INDESIT company

Model type:
AVXD109EU

Commercial code:
F029621

n1040306: Reduction of cabinet depth on ARISTON EVOII 6kg washing machines produced at Bre

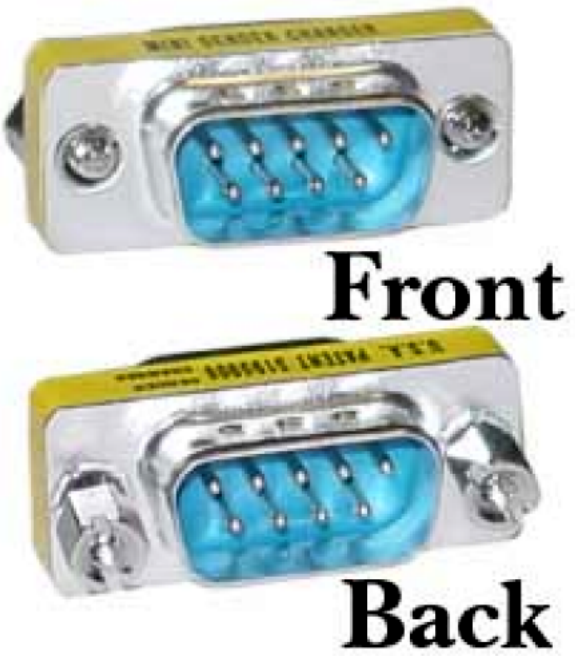
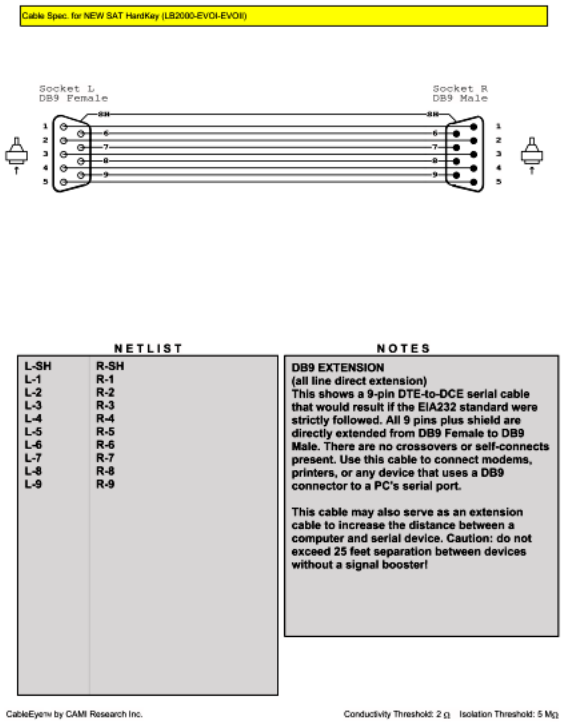
From serial no. 30915.0001, ARISTON EVOII 6kg washing machines affected by this note have been modified due to the reduced depth of the cabinet.
The modified models have a new industrial code.
The items affected by the modification are: cabinet, packing kit, top, product dispenser lid (including solenoid valve) and

solenoid valve.
Regarding the packaging kit, top, product dispenser lid and solenoid valve, the Replacements Warehouse will continue to manage premodification and new parts.
The premodification cabinets will be managed while stocks last, after which, in case of cabinet replacement the new cabinet, top and solenoid valve must be used, referring to the spare parts list for the relevant model.
Given below is a list of models affected by the modification with relevant new and premodification parts:

AVXD109EU (industrial codes: new 91296210001, premodification 91296210000);
AVXD129EX (industrial codes: new 91296220001, premodification 91296220000);
AVXL105EX (industrial codes: new 91296600001, premodification 91296600000);
AVXL109R (industrial codes: new 91297720001, premodification 91297720000);
AVXL89EU (industrial codes: new 91296230001, premodification 91296230000);
AVXD129EU (industrial codes: new 91284980101, premodification 1284980100);
AVXL109EU (industrial codes: new 91296240001, premodification 91296240000);
AVXD125FR (industrial codes: new 91284990101, premodification 91284990100);
AVXL100FR (industrial codes: new 91295430001, premodification 91295430000);
AVXL120FR (industrial codes: new 91295430001, premodification 91295430000);
AVXL88IT (industrial codes: new 91295180001, premodification 91295180000);
AVXL108IT (industrial codes: new 91284970101, premodification 91284970100);
Cabinet: premodification 095747, new 097709;

Packing kit: premodification 095741, new 094777;
Top: premodification 095738, new 097710;
Product dispenser lid (including solenoid valve): premodification 095740, new 097711;
Solenoid valve 1E2U: premodification 095739, new 097712.

AVXL105TK (industrial codes: new 91284830101, premodification 91284830100);
Cabinet: premodification 095747, new 097709;
Packing kit: premodification 095741, new 094777;
Top: premodification 095738, new 097710;
Product dispenser lid (including solenoid valve): premodification 096021, new 097715;
Solenoid valve 1E2U: premodification 095739, new 097712;
Solenoid valve 1E1U: premodification 096022, new 097716.

n1040381: Drain pump with bayonet-style filter - front Loading Brembate

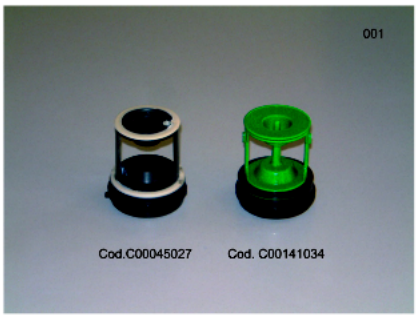
From serial no. 50720.0001 a new drain pump with bayonet-style filter has been installed on all front loading washing machines manufactured in Brembate.

New parts:
C00119307 - Drain pump
C00141034 - Pump filter kit

Premodification parts:
C00092264 - Drain pump
C00045027 - Pump filter kit

The new parts can be used instead of premodification ones.

n4008f00: Thermic link wire removed on three-phase motor

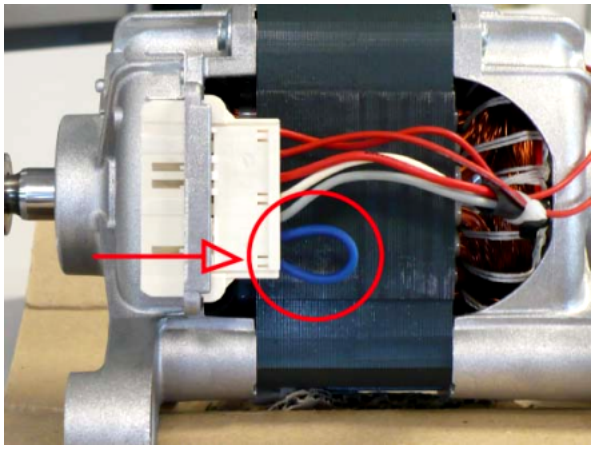
Attention!
When you assist the premodification models using the new motor code you MUST use the thermic link wire code C00265838.

In the attached image you can see the fixing of thermic link wire in the motor therminal box.

TRIPHASE P40 46 L – INOX TUB
C00265827 new motor without thermic link wire - C00116103 premodification motor with thermic link wire

TRIPHASE P40 46 L – PLASTIC TUB
C00265826 new motor without thermic link wire - C00142390 premodification motor with thermic link wire
